PLANNING COMMISSION STAFF REPORT

AGENDA ITEM: Planning File No. MAJ-25-0003: A final review of a remodel to a commercial property consisting of a fast food restaurant located at 960 N. Ten Mile Drive.

960 N. Ten Mile Drive, MAJ-25-0003, Final Major Site Plan Review

Figure 7: Proposed Landscaping

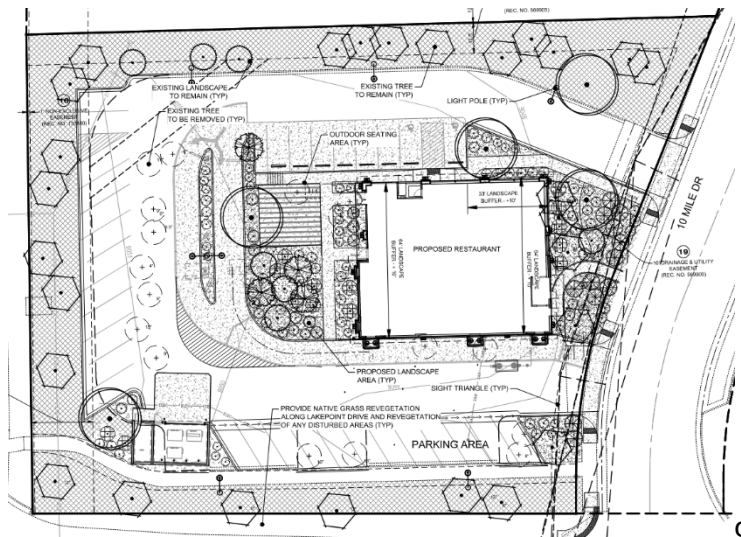
The application shows 27 existing trees to be preserved and 16 new trees to be planted, including 7 blue spruce, 5 narrowleaf cottonwood, and 4 aspen. The application lists 120 shrubs to be provided. Two trees and numerous shrubs are shown near the driveway exit, with additional shrubs and trees located between the building and N. Ten Mile Dr. The application meets the landscaping requirements. Staff notes that in order to meet sight triangles for vehicle safety, landscaping should not be required too close to the driveway access. If Planning Commission finds that the proposed landscaping meets their request for additional landscaping to screen the development from the road and the mixed-use development across N. Ten Mile Dr, the application meets this standard.

Parking Area Landscaping (§180-6.14.3.F.): Any parking lot providing 20 or more parking spaces must provide a landscaping area equal to at least 6% of the total paved area. At least 50% of the required parking lot landscaping area must be internal to the parking area. The remainder must be within 10 feet of the perimeter of the paved area. This area must include 1 tree and 2 shrubs per 150 square feet of required area, or fraction thereof. Parking lot islands must be at least 8 feet in width and length and contain at least 1 tree. With a paved area of 20,920 sf, 1,255 sf of parking lot landscaping is required, with 628 sf of that area being internal to the parking area. Within this area, 8 trees and 16 shrubs are required.

The application shows 1,255 sf of landscaping within 10 feet of the parking area, including the 8 required trees and 16 shrubs. The application meets this requirement.

Figure 10: Final proposed landscaping buffers

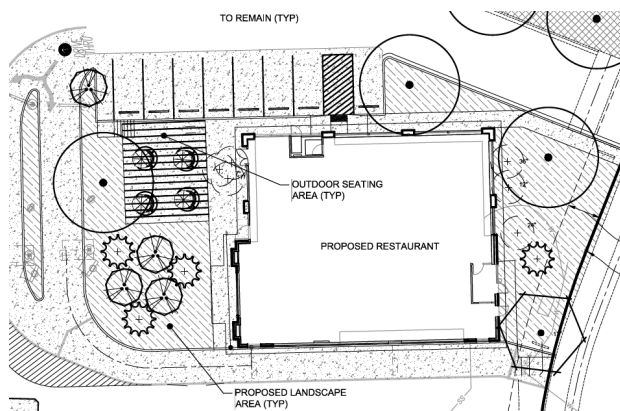
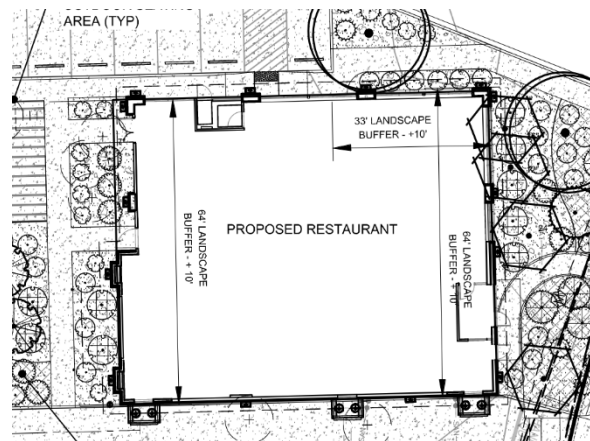
Parking lots or paving abutting a building shall provide a landscaped area of 5-10 feet in width, with half of the area being 10 feet in width and the area running along 50% of the building. If less than 50% of the required parking spaces are in the front of the building, the landscape buffer may be reduced to 35% of the length of the building, with Planning Commission approval. The project qualifies for the reduction to 35%.

The application materials currently show 222 linear feet of the building abutting paving. Of those 222 feet, approximately 83 feet incorporate a landscape buffer between the paving and the building. All provided buffers are between 5-10 feet. At the time of sketch plan, the Planning Commission did not comment on landscape buffers. If Planning Commission approves the reduction of landscape buffers to 35%, the application meets this requirement.
